## **Appendix 12**

### **EA Public Comments**

Comment Sheet  
Brunswick-Topsham, Frank J. Wood Bridge, MaineDOT WIN 22603.00  
National Environmental Policy Act

**TYPICAL STRUCTURAL TRUSS BETTERMENT  
ELEVATION - SPAN 1  
(SIMILAR ALL THREE TRUSS SPANS)**

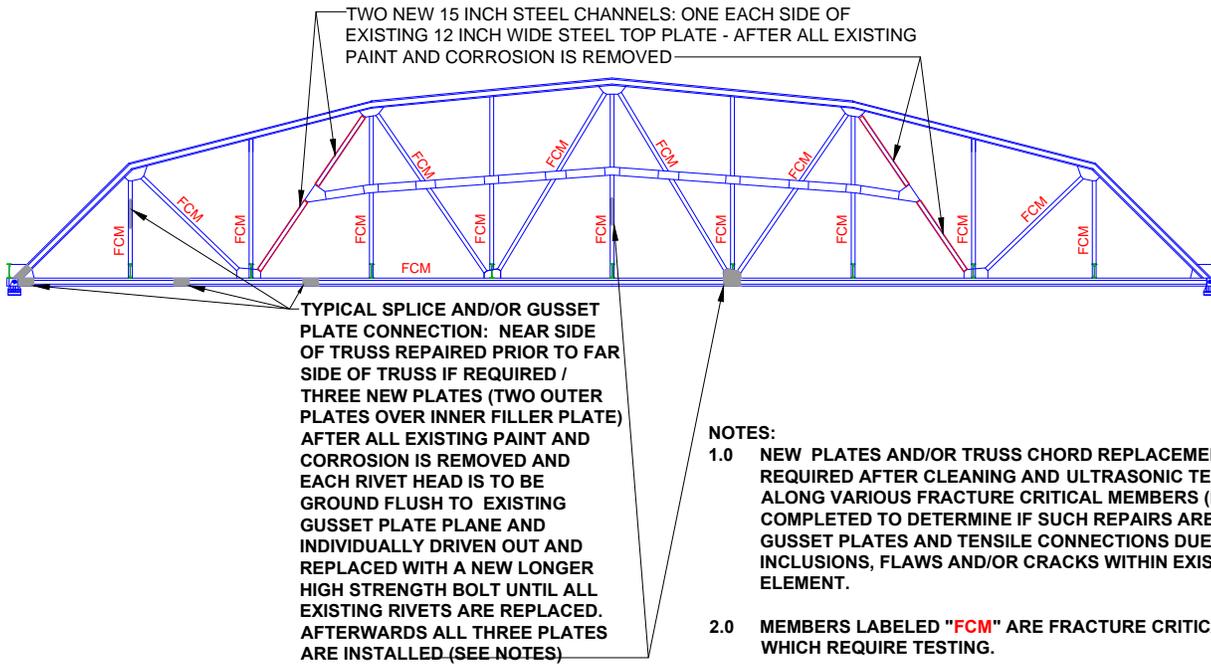
Any welds found and containing detrimental internal inclusions or flaws after ultrasonic testing and any members or gusset and connection plates found to have excessive cross sectional loss due to corrosion would either be replaced or splice repaired and the post-tensioning of truss elements would be implemented as needed. If any main support pins were found to contain internal flaws etc. the location, size and orientation would be assessed with respect to structural adequacy and the pin would be replaced or left in place and monitored from time to time in the future. Refer Sheet 1 (Appendix A Photographs and Illustrations - Truss Betterment Repairs) for additional information.

## Exodermic® Deck

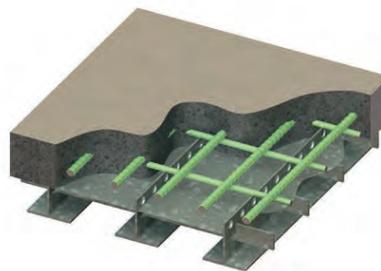
The exodermic deck would consist of a non-composite precast concrete 5 inch overlay with a 2 inch concrete overfill above the top of the steel bearing bars with a concrete cast in place in-filled stringer haunch atop and attached to preinstalled welded top flange stud connectors. Refer Sheet 2 (Appendix A Photographs and Illustrations - Exodermic Concrete Filled Steel Grid Deck) for additional information.

**STRUCTURALLY RETROFITTED NON-FRACTURE CRITICAL TRUSS ELEVATION TRUSS SPAN 1 (SIMILAR ALL THREE TRUSS SPANS)**

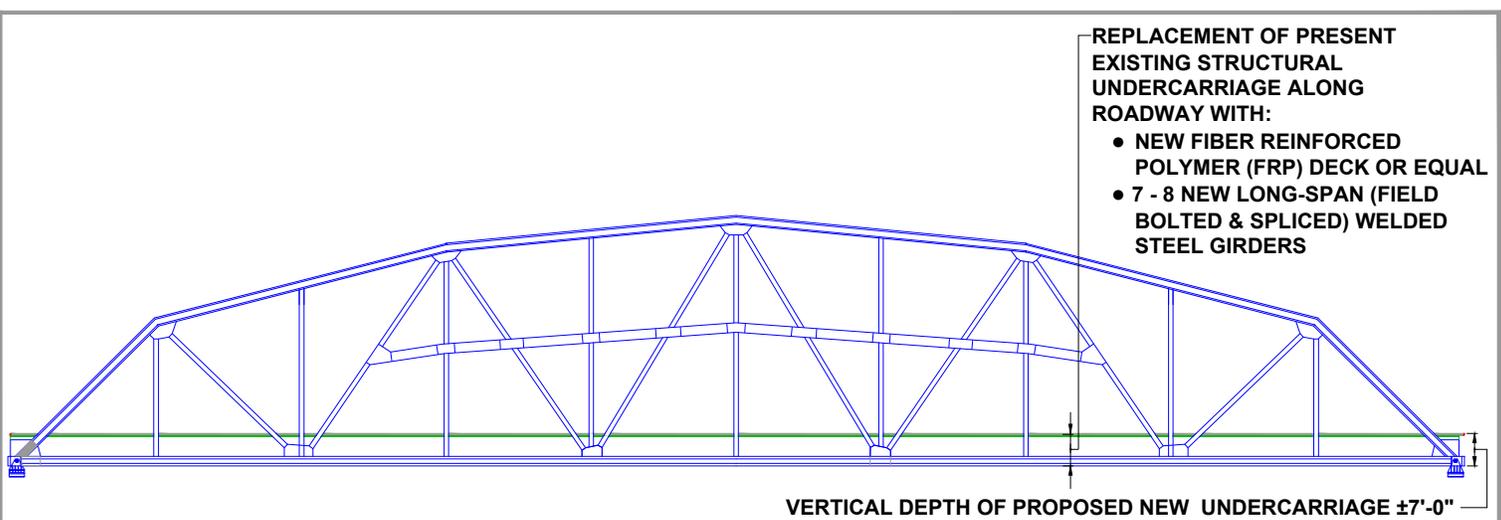
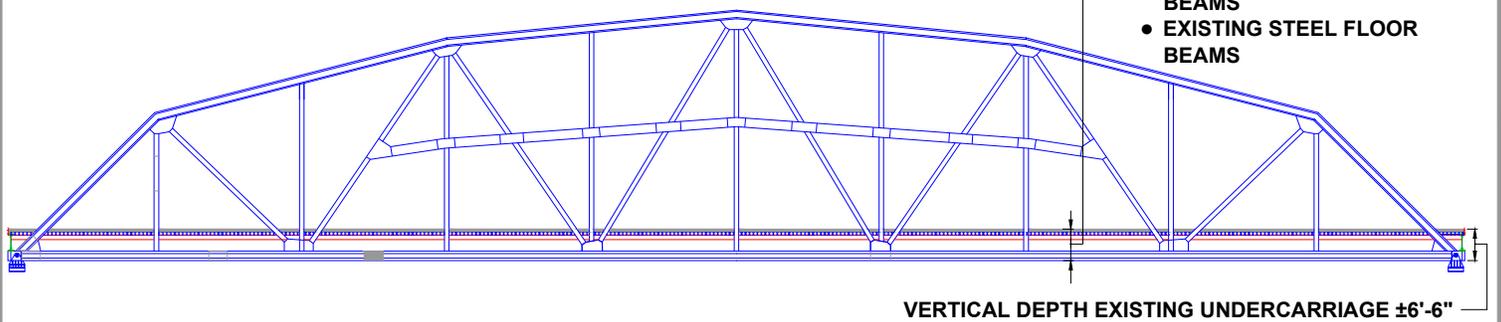
Refer Sheet 3 (Appendix A Photographs and Illustrations - Preliminary Evaluation: Replacement of Existing Structural Undercarriage) for additional information.

REPLACEMENT OF PRESENT EXISTING STRUCTURAL UNDERCARRIAGE ALONG ROADWAY WITH:

**NOTE:**  
 ALL EXISTING EXISTING TRUSSES, SWAY FRAMES AND TOP LATERAL CROSS BRACING FRAMES ARE TO BE STRUCTURALLY UPGRADED AS REQUIRED TO MEET OR EXCEED AASHTO LATERAL SEISMIC, WIND FORCE AND DISPLACEMENT REQUIREMENTS PRIOR TO INSTALLATION OF NEWLY PROPOSED ROADWAY UNDERCARRIAGE MEMBERS.
